## DME Electrical Wastegate Valve Faults - Adaptation Limit Positions Not Detected

F22 (2 Series Coupe)	F23 (2 Series Convertible)	F30 (3 Series Sedan)	F32 (4 Series Coupe)
F31 (3 Series Sport Wagon)	F33 (4 Series Convertible)	F34 (3 Series Gran Turismo LCI)	F36 (4 Series Gran Coupe)
G12 (7 Series Sedan)

With the B46O, B48M, B48O, and B58M engines produced up to 7/31/2016.

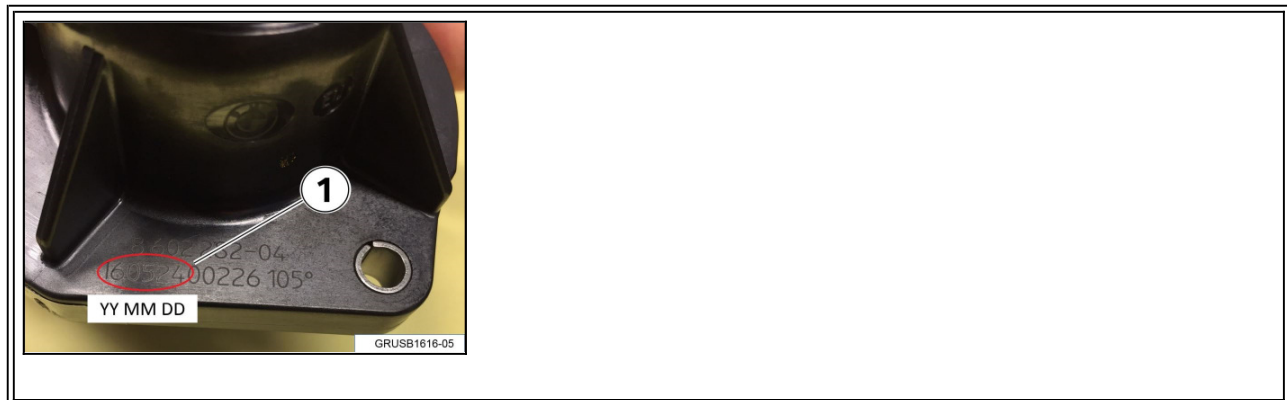
In order to reduce the incompatible electromagnetic radiation, individual wires of the vehicle wiring harness were twisted.

Although the improved vehicle wiring harness has the same part number, it can be identified by the index (1) at the rear of the part number. (2) indicates the last 7 digits of the part number.

1. Perform diagnosis using the latest version of ISTA.
2. Inspect and / or replace the Engine sensor system module 1 vehicle wiring harness (see graphic for part number location).

3. Replace the “Engine sensor system module 1 vehicle wiring harness“. Obtain the required part number from the Electronic Parts Catalogue (EPC).
